**Comment Summary – January 13, 2025 (5<sup>th</sup> Submission)**  
**Zoning By-law Amendment Application – WDD Main St. Inc.**

RE: **NPG Comments  
Main St  
RE: Application for Zoning By-law Amendment & Draft Plan of Subdivision**

**Re: Zoning By-Law Amendment 5th Submission  
11 Main Street (Morrison)  
Puslinch, ON**

**RE:** Hydrogeological Review Comments - 5th Submission  
WDD Main Street Inc. - 11 Main Street, Morriston (Puslinch), Ontario  
Proposed Residential Subdivision  
Zoning By-law Amendment / Draft Plan of Subdivision Application

Drawing  
**EXTERNAL GRADING PLAN  
(OCHS STREET)**

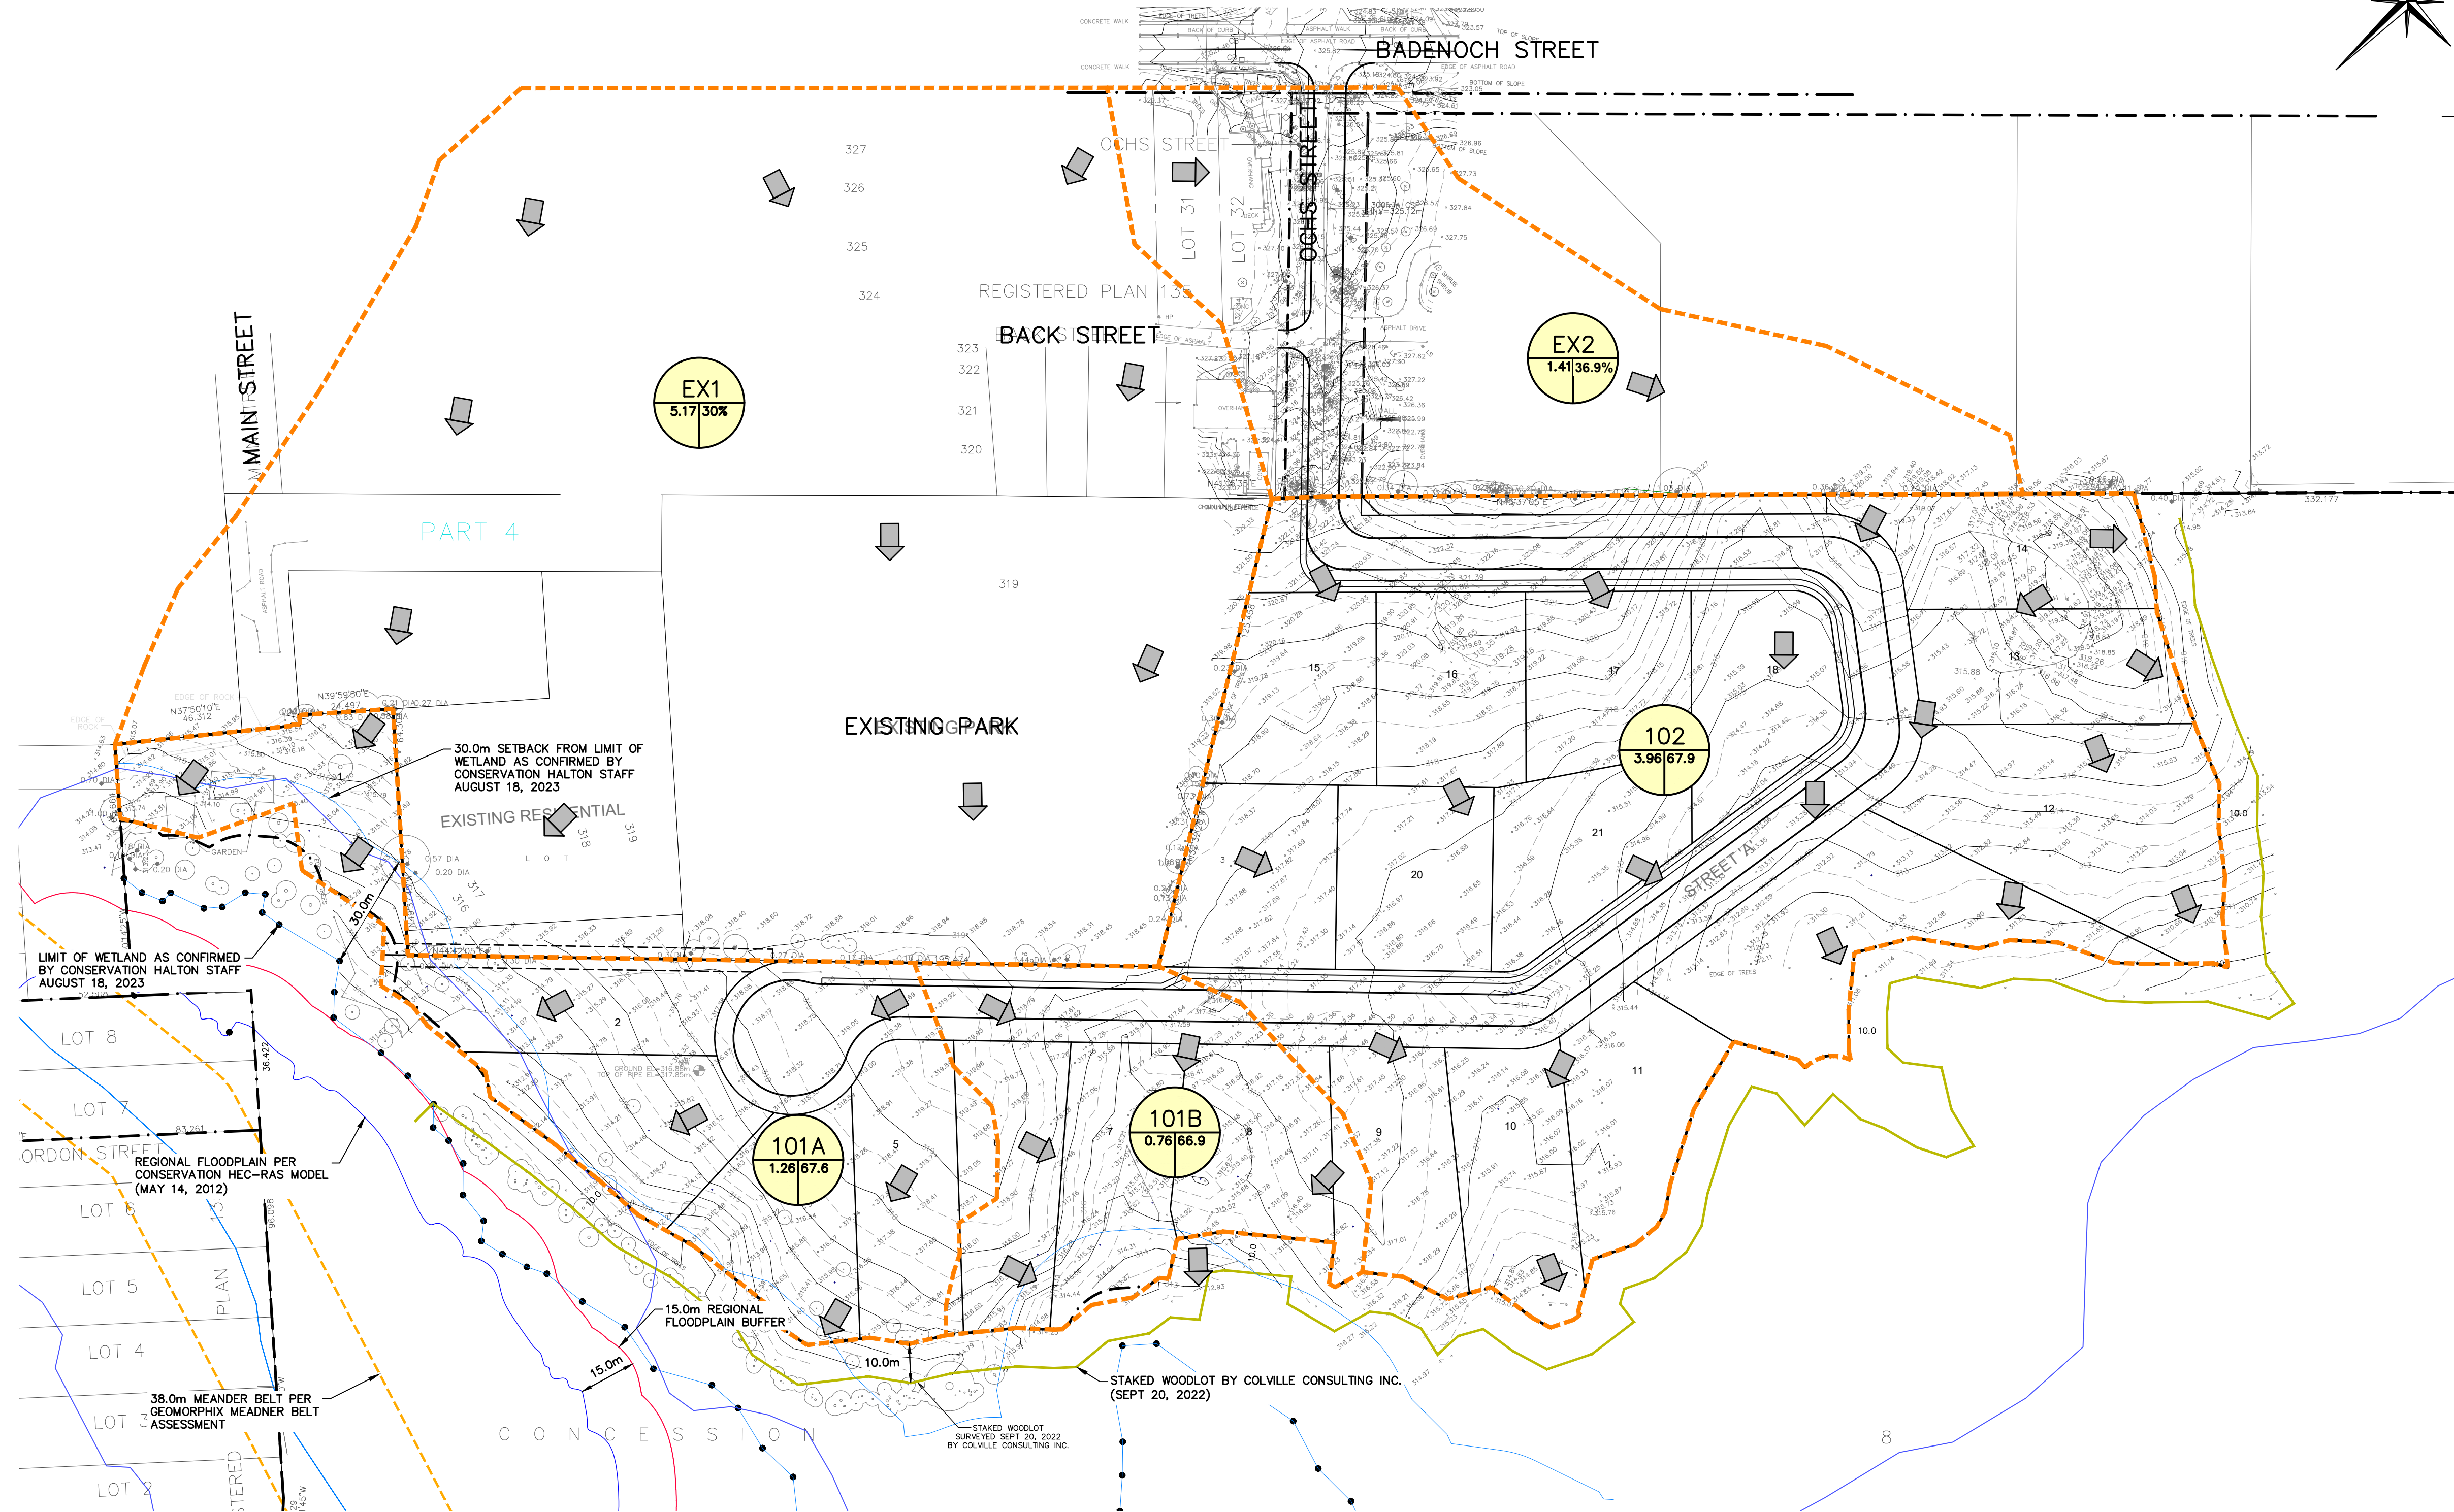
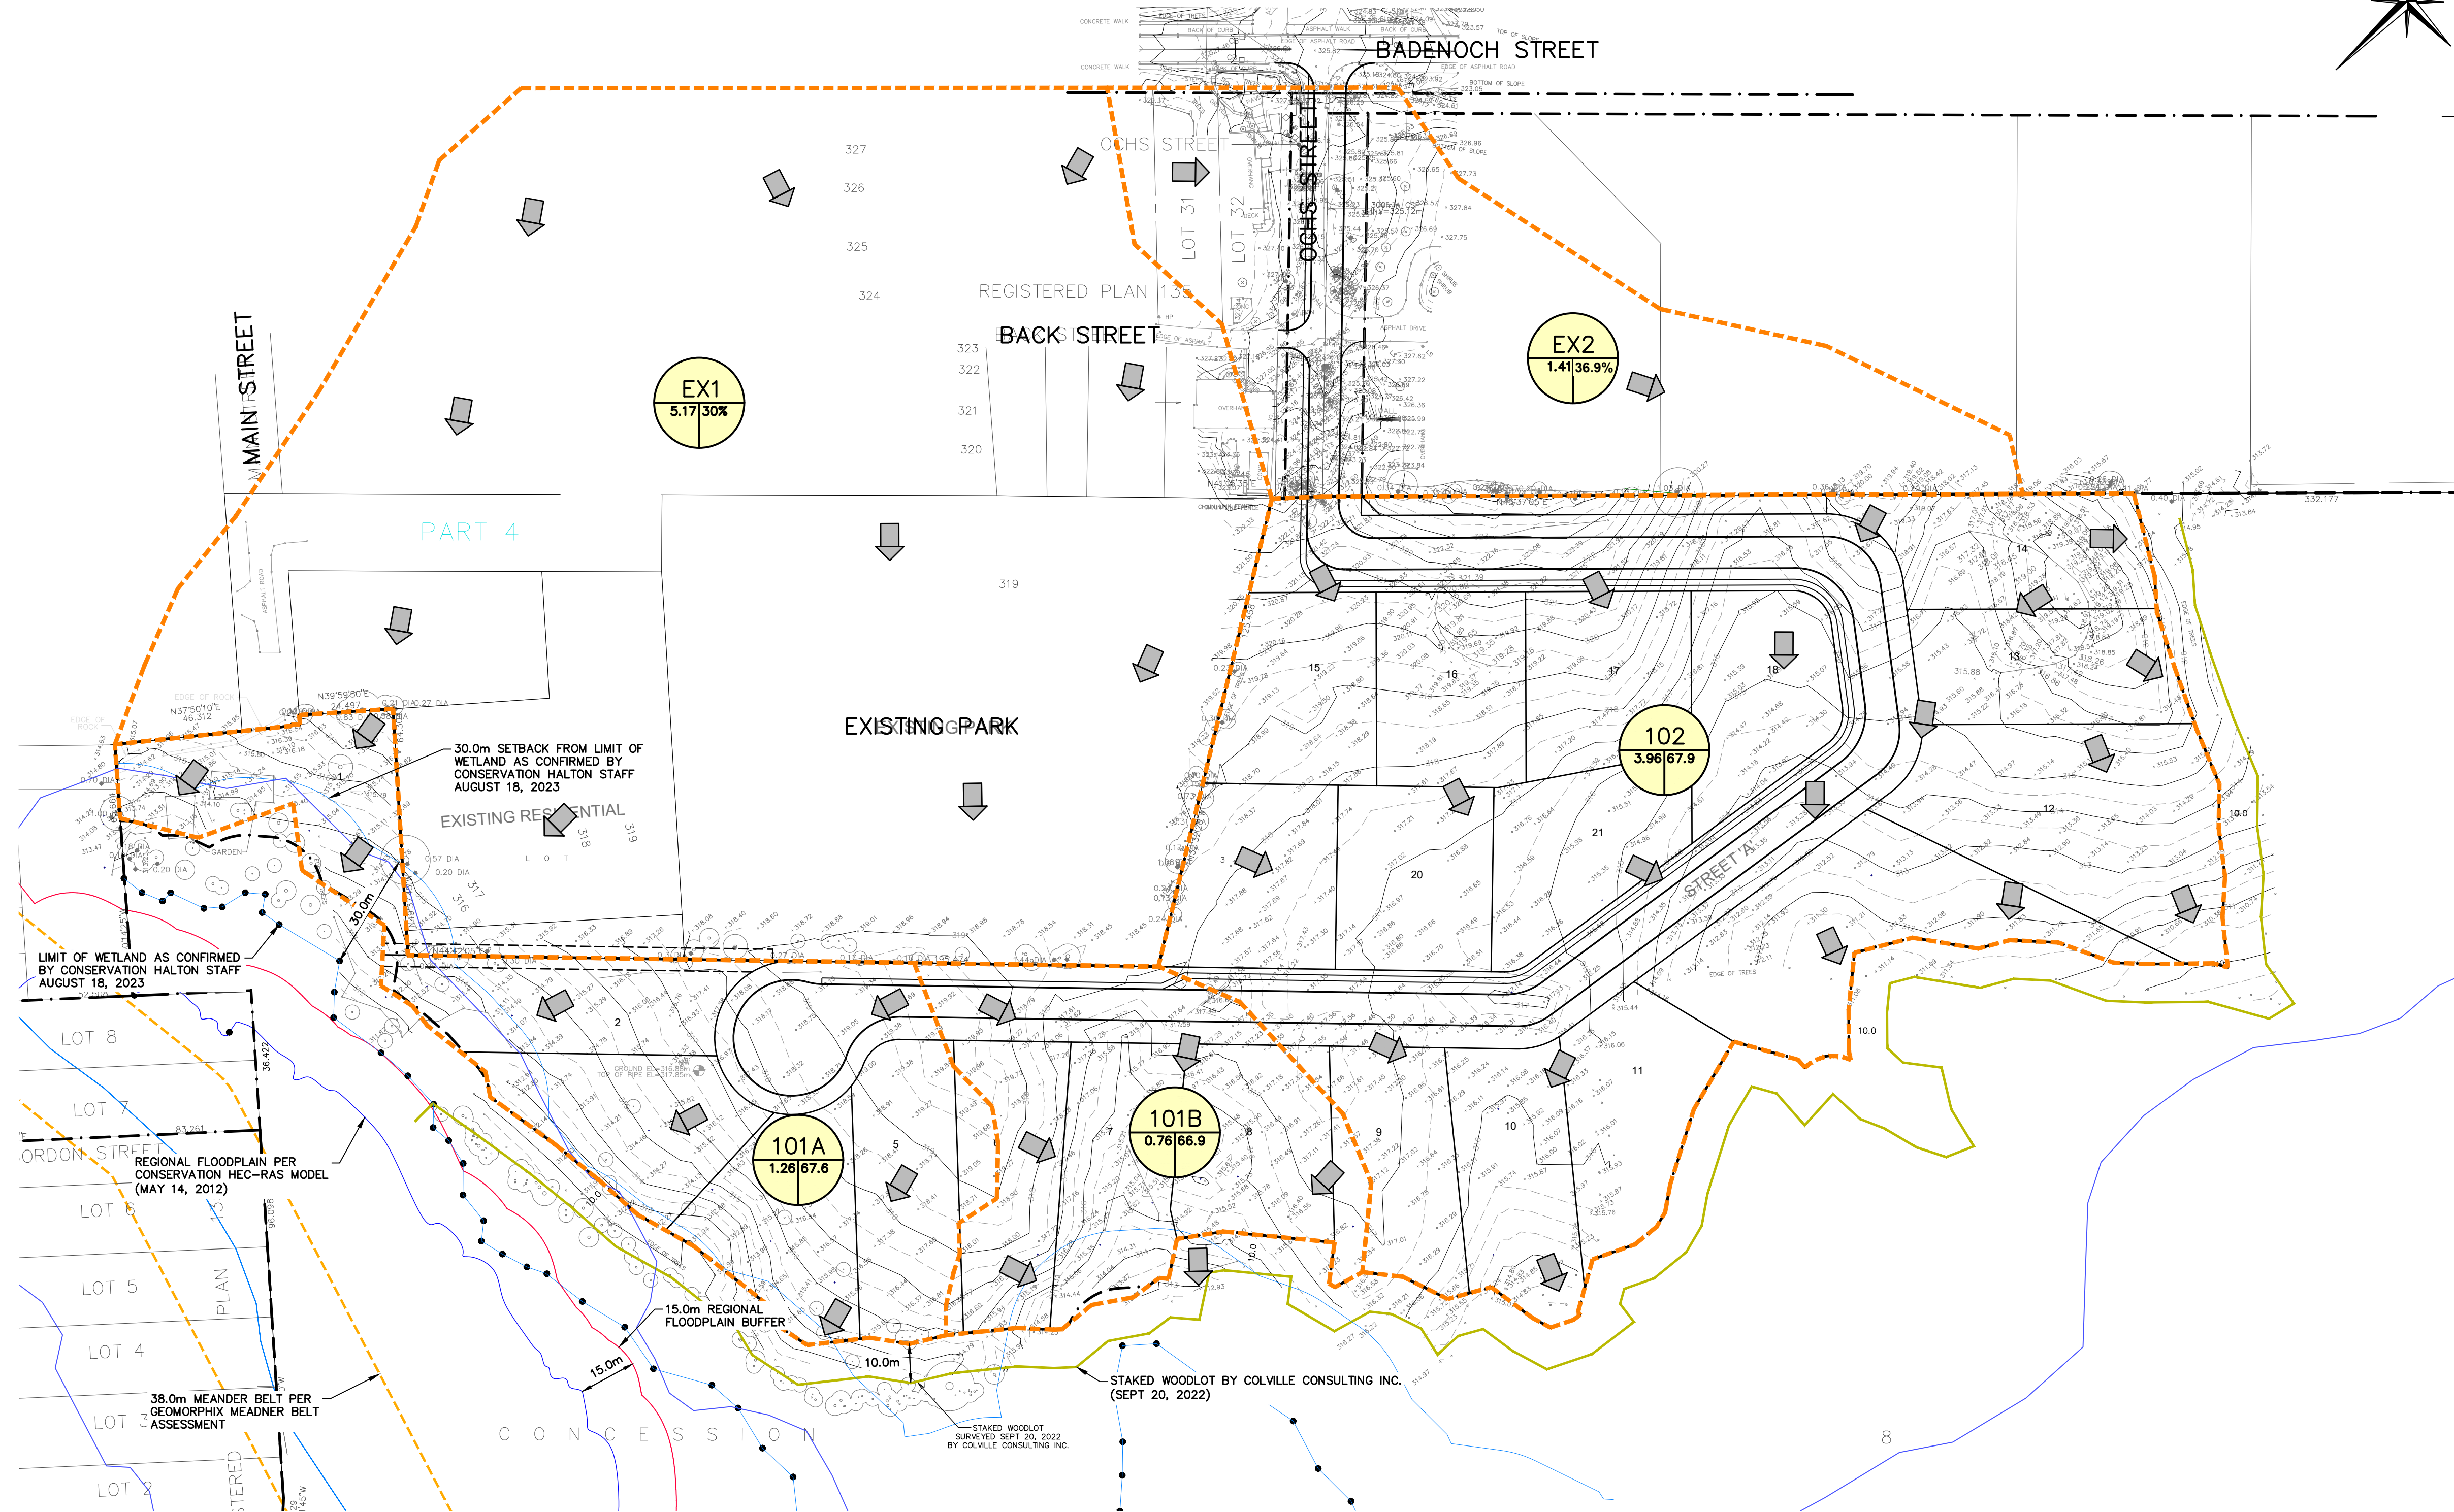
19.	Ochs Street Cross-Section	Engineering Plans	February 9, 2024	<p><u>GEI Comment (February 9, 2024)</u>          Please provide cross-sections for the proposed Ochs Street right-of-way, including proposed retaining walls and swales due to their close proximity to existing buildings.</p> <p><u>Crozier Response (September 2024)</u>          Cross-sections of the proposed Ochs Street right-of-way have been prepared and can be referenced on Figure 5.</p> <p><u>GEI Comment (September 27, 2024)</u>          No further comment.</p>
